PEX 8508

PCI Express Switch

Silicon Revisions and Errata List

Version 1.7

Erratum #24 – Dropped SKIP Ordered Set when Exiting L1 Power Management State

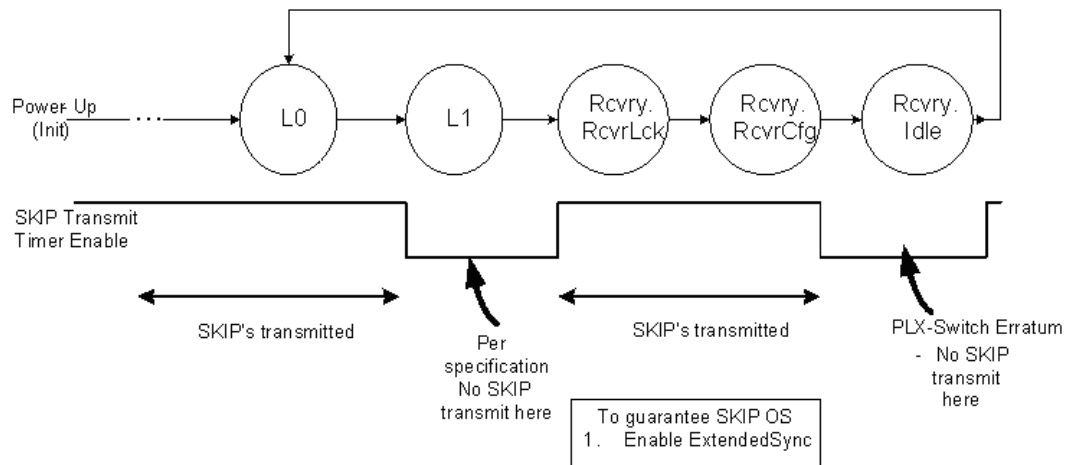
When exiting from the L1 Power Management (PM) state, there is a narrow window (recovery.idle state) during which SKIP ordered sets are not transmitted by the PEX8508. The exit from L1 PM state steps through 3 sub-states:

For the duration in which the link is in Recovery.idle state (waiting for receipt of 8 Idle symbols) there are no SKIP ordered sets transmitted by the PEX8508. Note that SKIP

The Figure below illustrates the behavior.

1. Disable the PEX 8508 upstream port's entry to L1 state for ASPM L1 [78h[1:0]] and PCI PM (device specific offset 1E0[7]) mechanisms.
2. Enable the ExtendedSync mode (Offset 78h[7]), to guarantee SKIP ordered sets are transmitted in the RcvrLck and RcvrCfg states (shown above)
